PROPOSED PRIVATE PLAN CHANGE 31 – FURTHER INFORMATION REQUEST

Application number: PC/0002/23
Applicant: L Cudby & LY&NZ Investment Limited
Address: 5 Pokuru Road & 540 Wallace Terrace, Te Awamutu 3800
Proposed activity(s): Proposed Private Plan Change 31 - T4 Growth Cell - Residential Live Zoning and Structure Plan

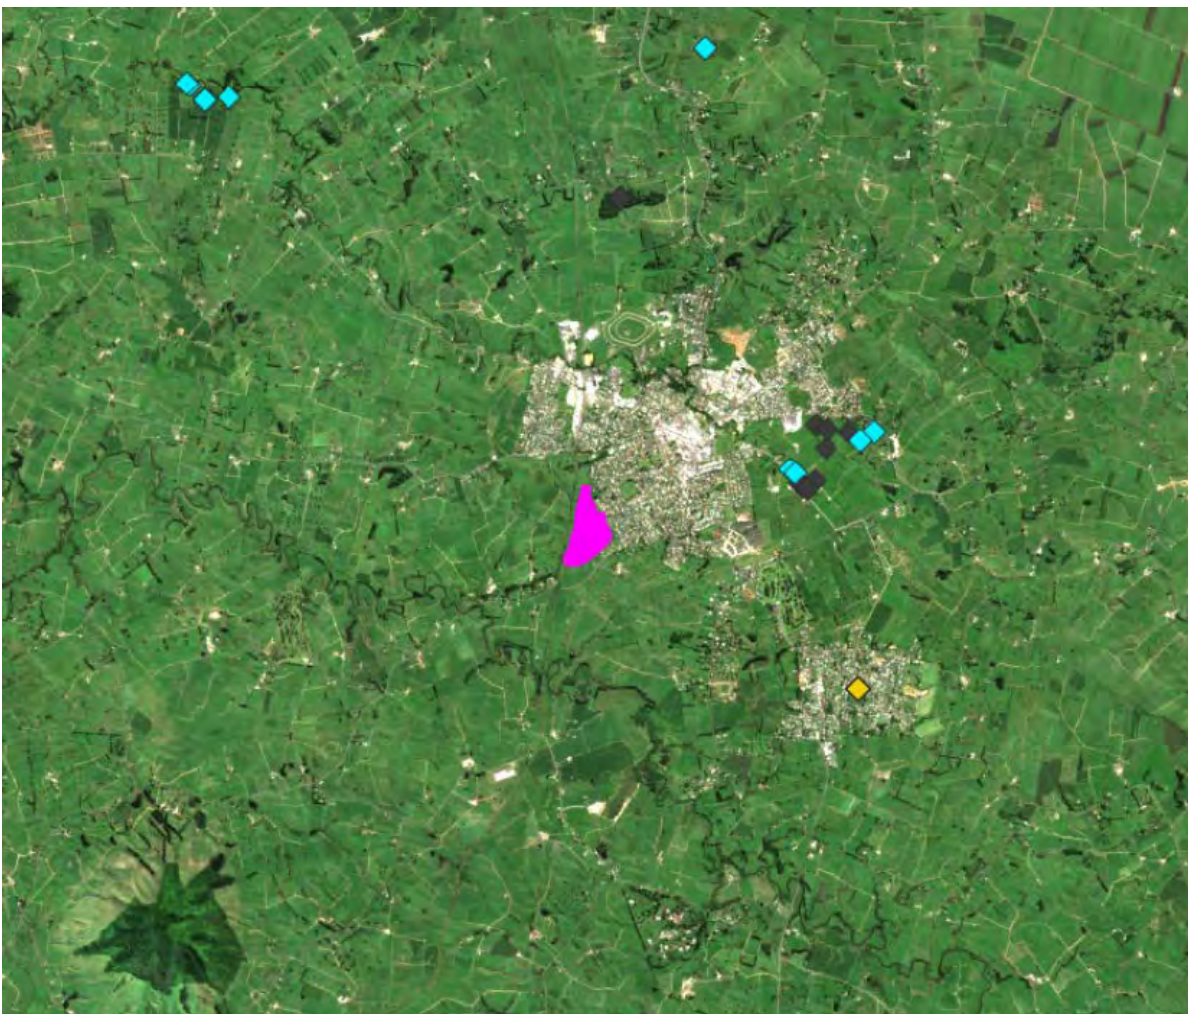
- ii) The author should have accessed the Department of Conservation bat survey database to understand the level of survey recorded in the area and patterns of detection. The author notes “no records of bat activity onsite or immediate surrounds”, while not acknowledging that there haven’t been any surveys within the site nor within what the author considers within the immediate surrounds of the site. The area to the southwest of Te Awamutu is best characterised as not surveyed (Figure 1). The closest survey to the site is the record referred to in the assessment which detected long-tailed bats in 2020. We consider a positive detection of long-tailed bats within 2km of a site should be considered with considerably more importance in an assessment of long-tailed bats which are highly mobile and have home ranges between 300ha and 5,600 ha which can span over a distance of 19km (Griffiths, 2007; O’Donnell, 2001).

- iii) The description of habitat preferences and habitat utilisation by long-tailed bats is not consistent with the current and emerging understanding of the use of long-tailed bats of modified and fragmented habitats, particularly in the Waikato. The site contains several features understood to be preferred by long-tailed bats in similar environs including wetlands, water ways, shelterbelts, large exotic trees. There also appears to be connectivity to the Puniu River through a series of vegetation patches and linear vegetative features.

- v) Long-tailed bats have been a matter of considerable importance in several recent plan changes and consent applications³ in the last several years in similar environments to the T4 growth cell and the lack of survey undertaken as part of this assessment is conspicuous in its absence. The presence and use of the site by the “Threatened – nationally critical” long-tailed bat may necessitate considerable changes to both the structure plan layout and suite of proposed development rules in the plan change area to manage effects on this species and its habitats.

- vi) We consider that at minimum a detailed bioacoustic survey of the site (potentially at two different times within the survey season to understand different usage patterns in different life history stages) is carried out by a suitably qualified and experienced bat ecologist. This is needed to understand the value of the site to long-tailed bats and thereafter carry out an assessment of the potential impacts of the proposal on these values. This information will also be required to understand how these impacts may be managed within the effects management hierarchy.
